1 SUBDIVISION OF THE LAND AND ASSOCIATED WORKS AT 46 TIVENDALE ROAD, OFFICER

FILE REFERENCE INT1757656

That a Refusal to Grant Planning Permit T160693 be issued for a subdivision and associated works at 46 Tivendale Road, Officer on the following grounds:

APPLICATION NO: T160693

Figure 1 – Proposed plan

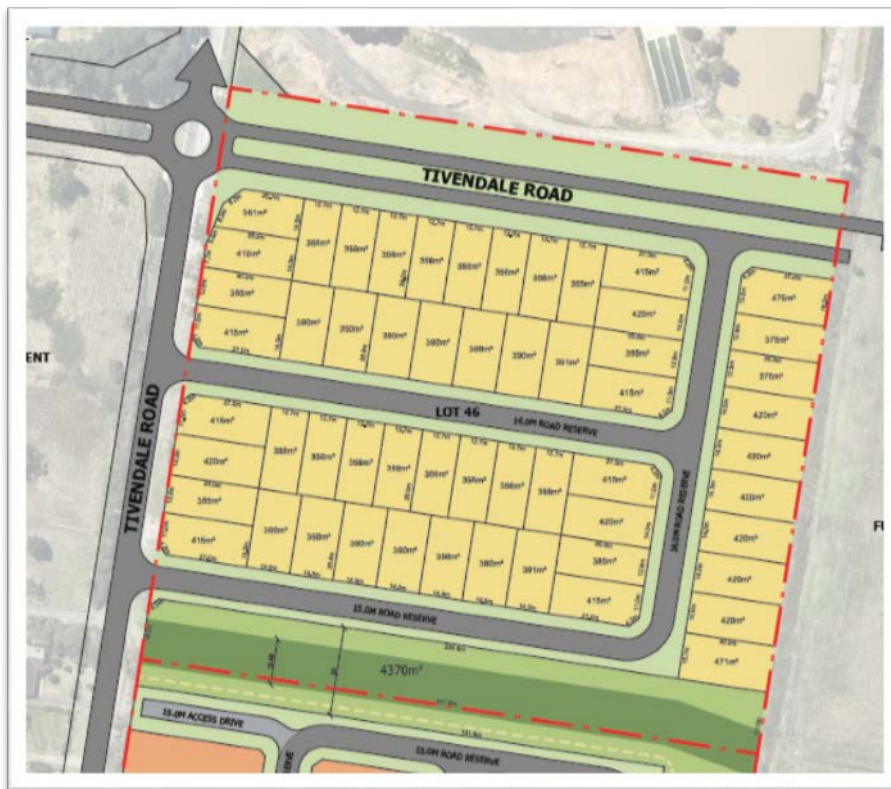
The proposed subdivision layout differs from the Officer PSP in the south of the site. The PSP identifies a drainage corridor along an open drain running in an east-west direction along the boundary. The drainage corridor / linear reserve has been significantly reduced in width, along with no consideration being given to the drainage corridors and sediment pond immediately abutting the subject site to the east.

As stated above, the drainage corridor and sediment pond areas do not align with each other, which results in an inconsistency with the PSP and does not allow for the appropriate integration between the two sites.

The applicant is proposing that the drainage corridor should be piped to allow for an adequately sized pipe to accommodate flows, rather than creating an open drainage corridor in this location in accordance with the PSP. It is further proposed by the applicant that the 15 metre wide road reserve, 10 metre wide Council reserve and 15.45 metre wide encumbered drainage reserve will adequately provide for a suitable drainage / linear reserve solution.

The PSP shows a total drainage and open space corridor of 100 metres which includes 20 metres of Council reserve on either side of an 80 metre encumbered drainage corridor. The subject site has a 10 metre wide un-encumbered open space Council reserve and an approximately 57.62 metre wide encumbered drainage reserve which equates to 1.19ha which is consistent with the land budget totals of the PSP. The remaining approximately 32.38 metre wide drainage and open space reserve is located within the adjoining site at 60 Tivendale Road.

Furthermore, lots with back fences are proposed along the extent of the south east corner boundary which affects the ability to provide for overlooking of the open space to increase the sense of safety/surveillance. This is inconsistent with the principles of Crime Prevention through Environmental design by having rear fences onto reserves rather than active frontages. It is considered that the proposal does not meet this provision of the PSP.

Plan 5: Future Urban Structure

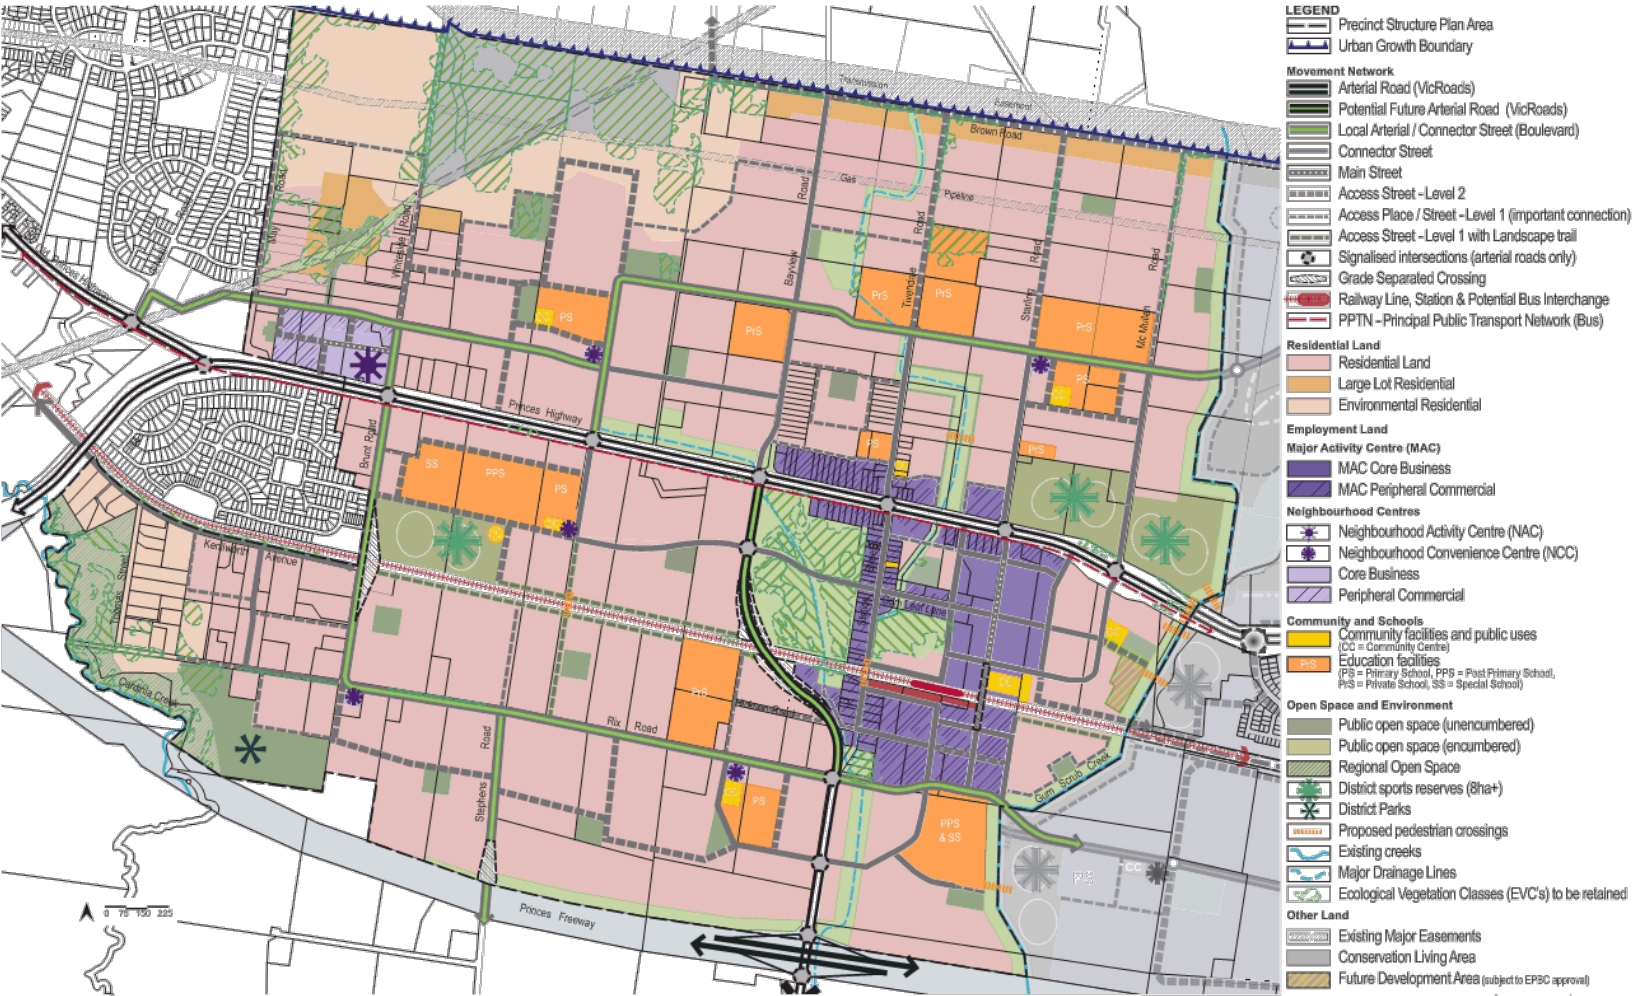
Plan 5 Future Urban Structure, describes how the PSP delivers the vision. It is considered that the proposed subdivision is not generally in accordance with plan 5 as the drainage corridor has been substantially reduced in size.

The reduction of the drainage corridor further inhibits the ability for the corridor to become a highly permeable and walkable open space trail network that the PSP envisages it to be.

Plan 6: Land Use Budget

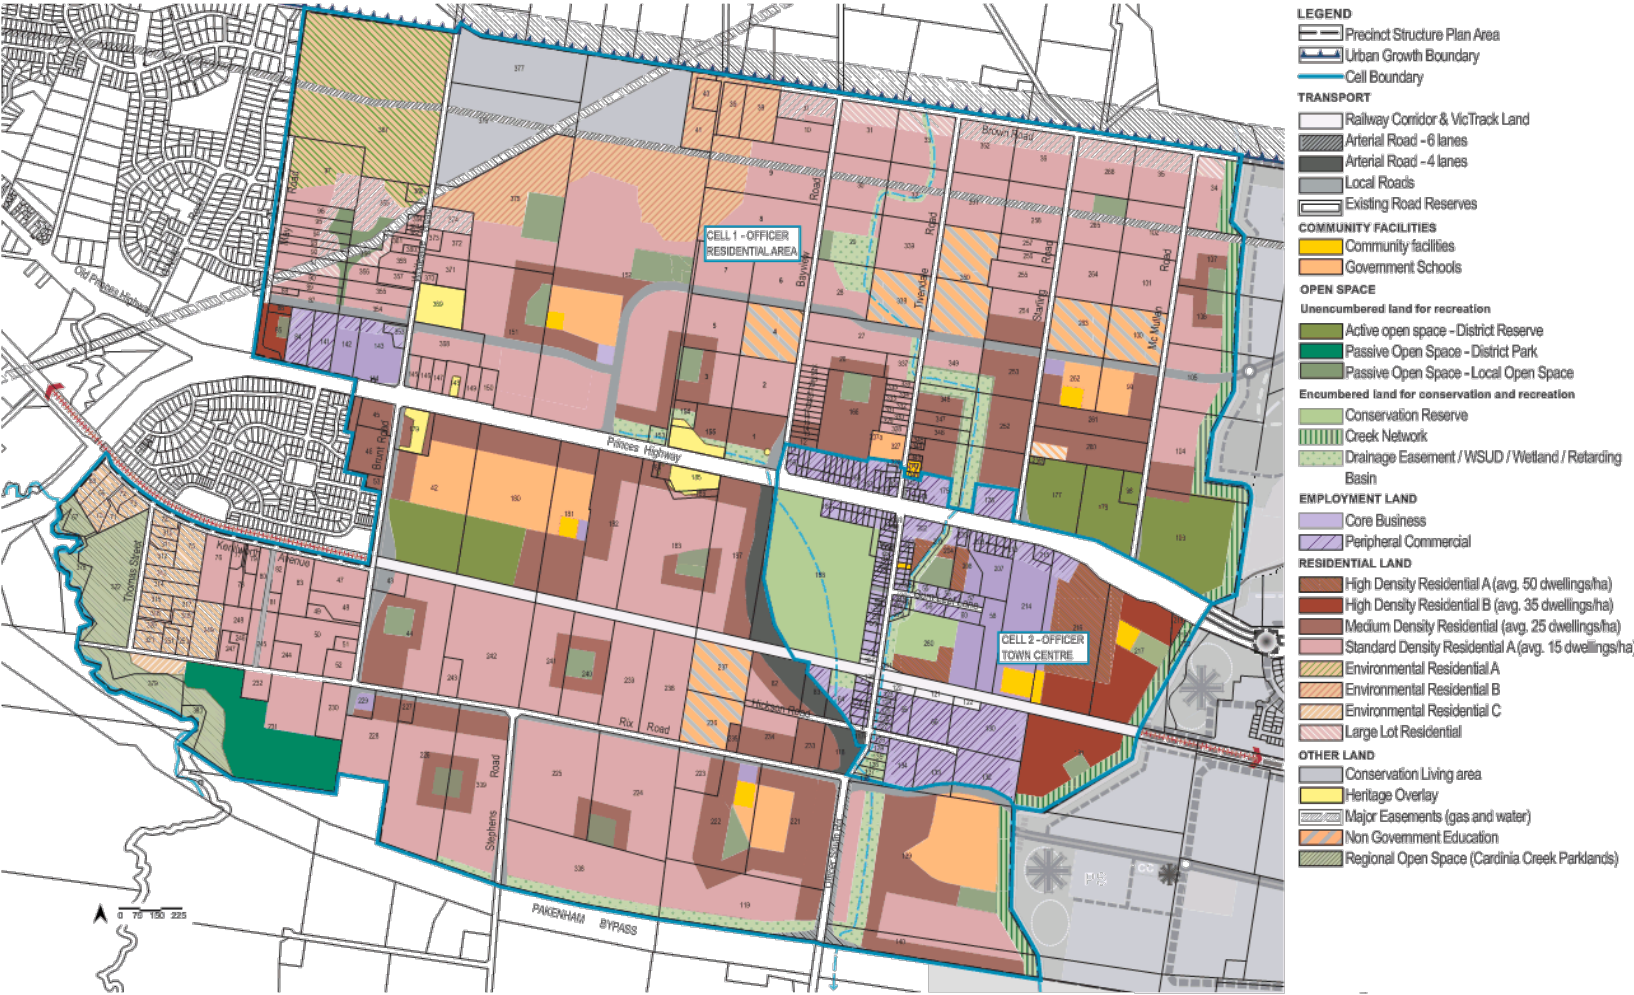
In response to the above, the proposal does not comply with the land use budget as the areas as described above have not been achieved within the proposed plan. The most concerning figure is the applicant is proposing to only deliver 4,370sqm of drainage easement/WSUD/wetland/Retarding Basin land instead of the approximately required 11,190sqm required by the PSP

Plan 12: Integrated Water Management

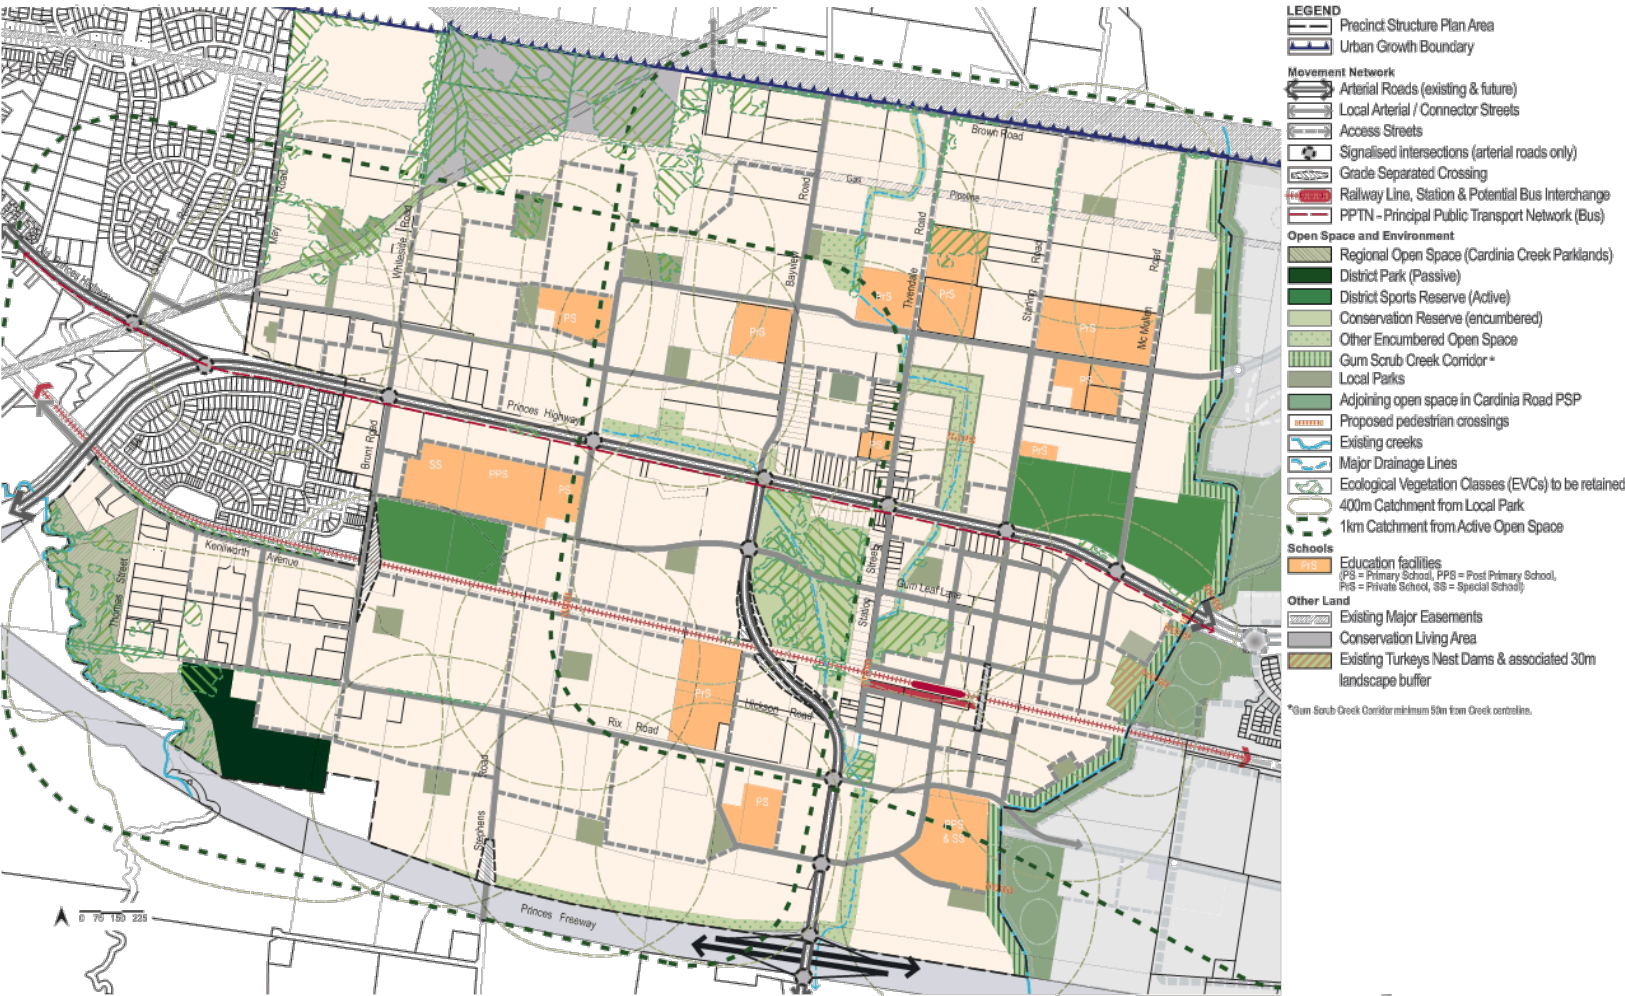
Plan 12 Integrated Water Management identifies the site as being part of a wider drainage corridor and having a retarding basin within it. The south west corner of the land is identified within the land subject to inundation overlay over it.

In response to the above, it is considered that the proposal fails to meet the relevant planning and design guidelines to be met as the reduction of the drainage corridor does not allow for the adjoining retarding basins to be well aligned and integrated into the broader open space network. The network is intended to be consistent through each site as shown within the PSP.

Plan 17: Walking and Trails

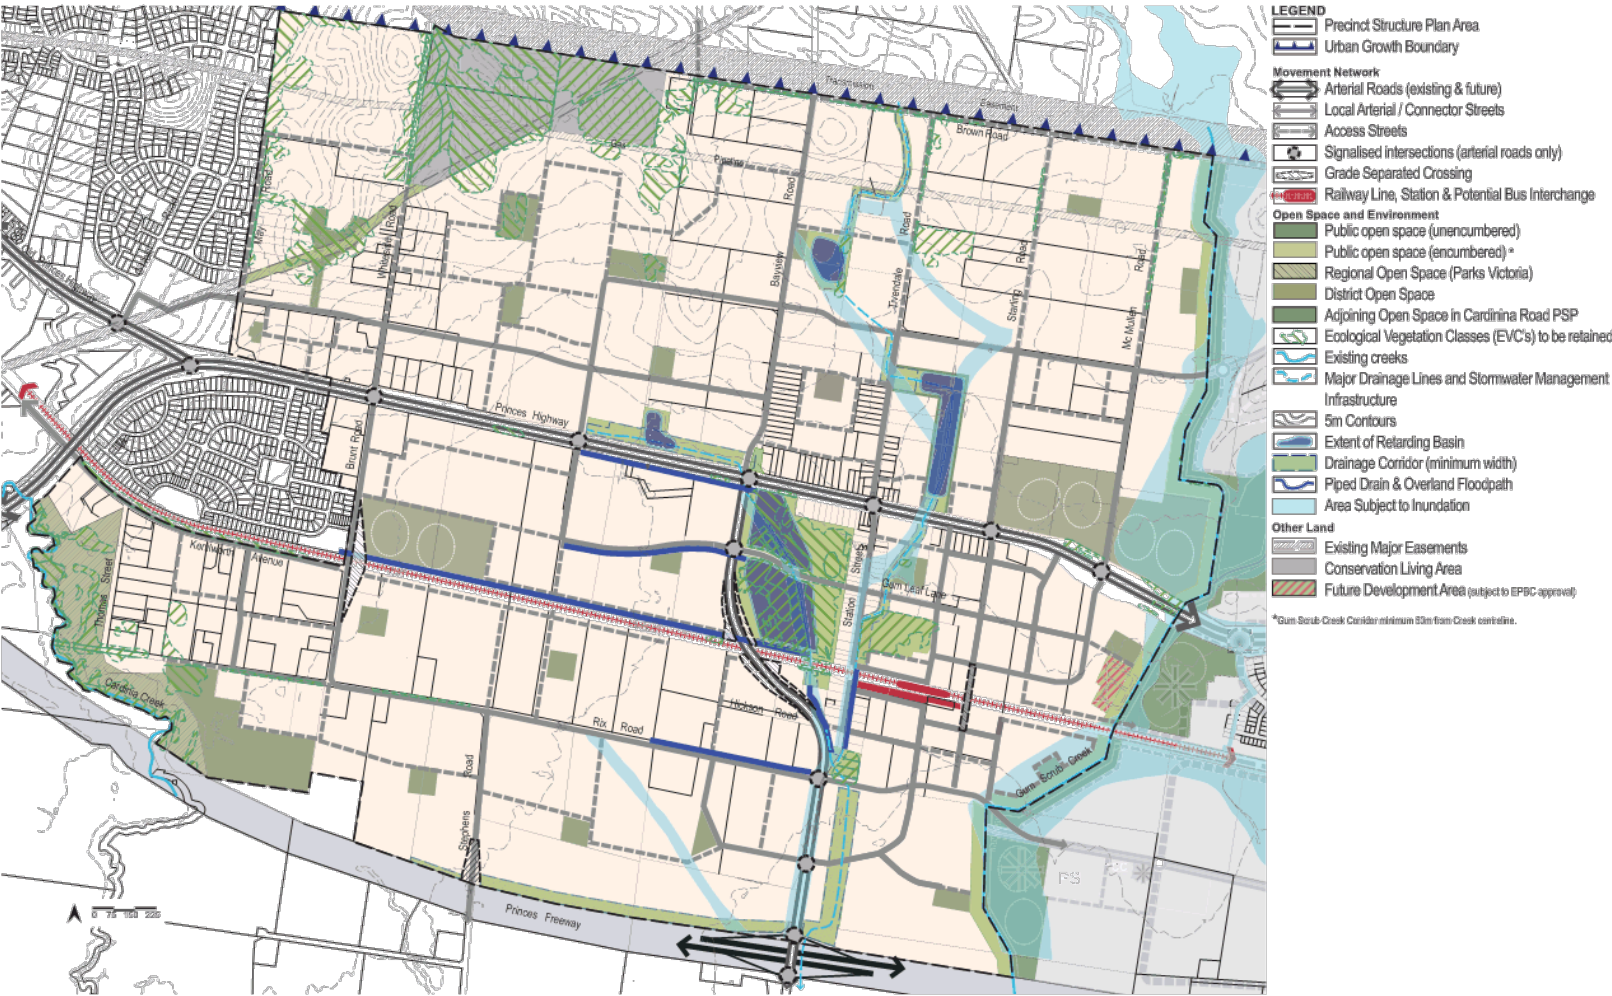
Plan 17 Walking and Trails shows a shared path within Tivendale Road and within the drainage corridor.

In response to the above, a 2.5 metre wide shared path along and within the open space network, in particular along the drainage network and provision of landscaping must be provided to achieve the objectives of the PSP, at present the reduction of the drainage corridor fails to achieve these outcomes.
